# Access Compliance Report

## Public Rights-of-Way

### (Curb Ramps)

Intersection ID: N/A	Main Street: EASTWAY_DR	Cross Street: N/A	Location: E
ADA ID: 370F2B24F6FE	Ramp Type: MedianPerp	Initial Pass/Fail: Fail	Overall Compliance: No
		Severity Score: 10

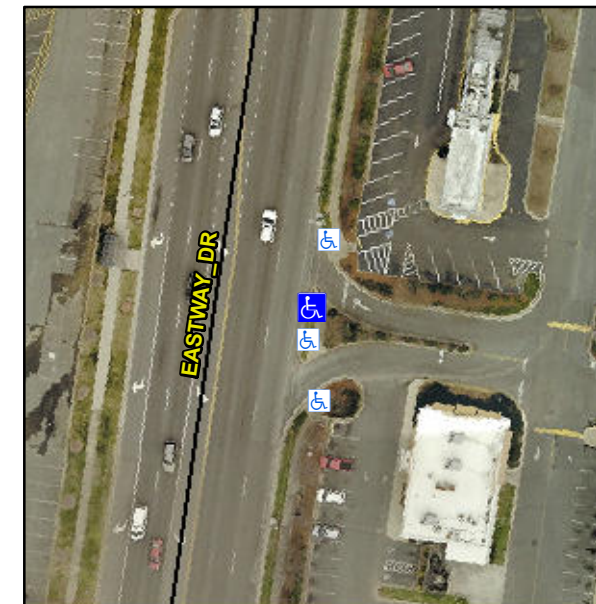
**Not Found, R304.5.1, R304.5.3**

Compliance	Description	Data	Compliance	Description	Data
N/A	Ramp Length (in)	57.0	Yes	Ramp Slope (%)	5.3
No	Ramp Width (in)	41.0	No	Ramp XSlope (%)	3.0
N/A	Flare Type LT	N/A	N/A	Flare Type RT	N/A
N/A	Flare Slope LT (%)	N/A	N/A	Flare Slope RT (%)	N/A
N/A	Flare Traversable LT?	N/A	N/A	Flare Traversable RT?	N/A
N/A	Landing Length (in)	N/A	N/A	DWS Provided?	N/A
N/A	Landing Width (in)	N/A	N/A	DWS Contrast?	N/A
N/A	Landing Slope (%)	N/A	N/A	DWS Length (in)	N/A
N/A	Landing X Slope (%)	N/A	N/A	DWS Full Width?	N/A
N/A	Landing Curb? (Y/N)	N/A	N/A	DWS Offset (in)	N/A
N/A	Shared Landing?	N/A			
N/A	Gutter Ponding?	N/A	N/A	Gutter Slope (%)	N/A
N/A	Gutter Lip Ht (in)	N/A	N/A	Gutter X Slope (%)	N/A
N/A	Painted X Walk1?	No	N/A	Painted X Walk2?	N/A
	X Walk 1 Direction	To N		X Walk 2 Direction	N/A
N/A	X Walk 1 Width (in)	N/A	N/A	X Walk 2 Width (in)	N/A
	X Walk 1 Slope (%)	8.2		X Walk 2 Slope (%)	N/A
	X Walk 1 X Slope (%)	0.1		X Walk 2 X Slope (%)	N/A

**Remove & Replace Entire Ramp.**
